**Project #22-063
Old Ephraim Apartments (Second Submittal)
Located at approximately 655 East 400 North**

<i>Project Name:</i>	Old Ephraim Apartments
<i>Proponent / Owner:</i>	Nathan Whittaker / GBN Enterprises LLC & KSF Prop. LLC
<i>Project Address:</i>	655 E. 400 N.
<i>Request:</i>	Design Review Permit
<i>Current Zoning:</i>	Campus Residential (CR)
<i>Type of Action:</i>	Quasi-Judicial
<i>Hearing Date</i>	February 9 th 2023
<i>Submitted By:</i>	Russ Holley, Senior Planner

RECOMMENDATION

Figure 2 shows the proposed site plan

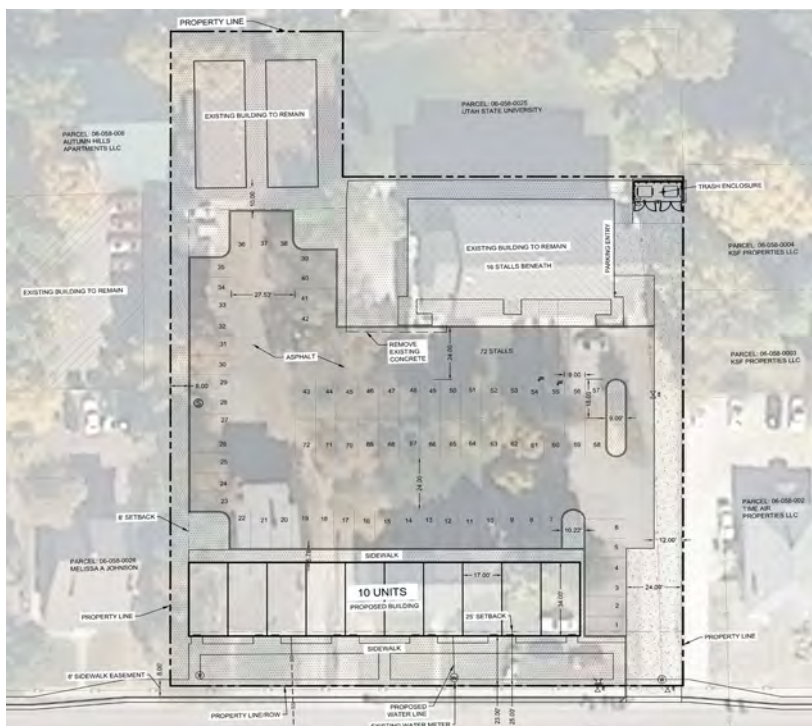
As proposed, the project does not meet the front building setback of 25 feet. The Planning Commission could, at their discretion, approved a ten-percentage deviation from the 25-foot standard. As conditions with front yard compliance, the project meets the setback requirements in the LDC.

3. The front (south) setback shall be 25 feet unless the Planning Commission approves a 23.5-foot setback as per the LDC 17.43.080.
4. The project shall provide 109 parking stalls for all buildings and uses on the 1.29-acre site or have an alternative parking plan approved as per the LDC 17.31. The new building shall provide bike parking as per LDC 17.31.
